From: [Keller, Michael](#)
To: [Webb, Julie \[Noble Energy\]](#); [Hefta, Mark](#); [Montoya, Mo](#); [Dennison, Doug](#); [Gordon, Seth](#)
Cc: [Eggert, Derek](#); [Coufal, Tommy](#)
Subject: FW: [**EXTERNAL**] Re: FW: SKR- injection pad (35-BV)
Date: Thursday, April 27, 2023 3:39:40 PM
Attachments: [image001.png](#)

From: Webb, Julie [Noble Energy] <julie.webb@chevron.com>
Sent: Thursday, April 27, 2023 12:25 PM
To: Keller, Michael <michael.keller@chevron.com>
Cc: Hefta, Mark <mark.hefta@chevron.com>; Montoya, Mo <mo.montoya@chevron.com>;
Dennison, Doug <dougdenison@chevron.com>
Subject: SKR- injection pad (35-BV)

Would you please reach out to CPW to see if we can get a variance to add a temporary above ground pipeline? This is for the SKR-65S98W/35SENE (location ID324427). Lat/long: 39.571770/-108.349840. Location is 100% in the NSO.

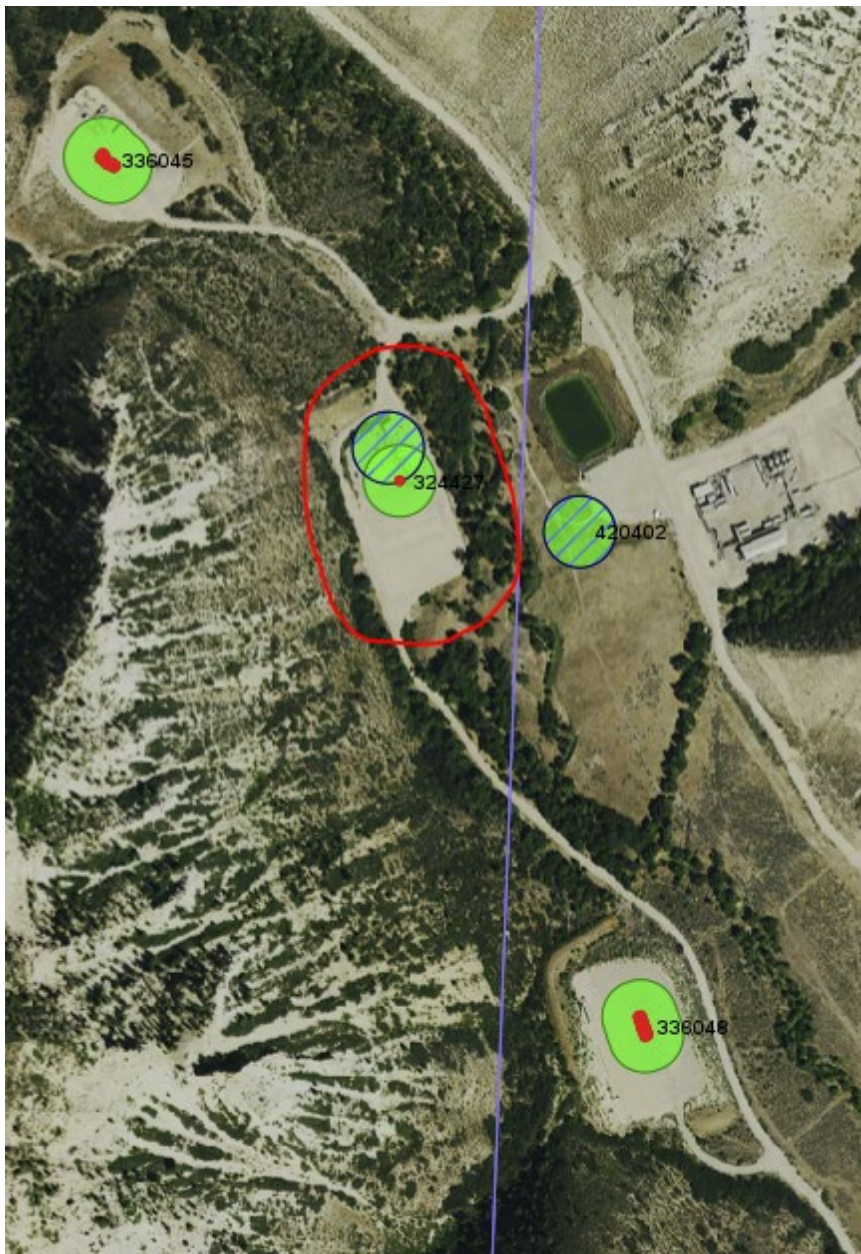
Reason we need the pipeline.

Backup SWD option for the event that trucking is shut down or limited.

This would bypass the CGF and go straight to the SWD

Can we add a temporary above ground line from permitted flowback line to existing valve

This would be used as an option if the main facility is backed up. This would inject water from frac on flowback into the injection well.

I think this change would still be covered by our original waiver. I do not see anything that would warrant a further review by CPW and a revised waiver letter. Please let me know if your team thinks additional documentation from CPW is needed.
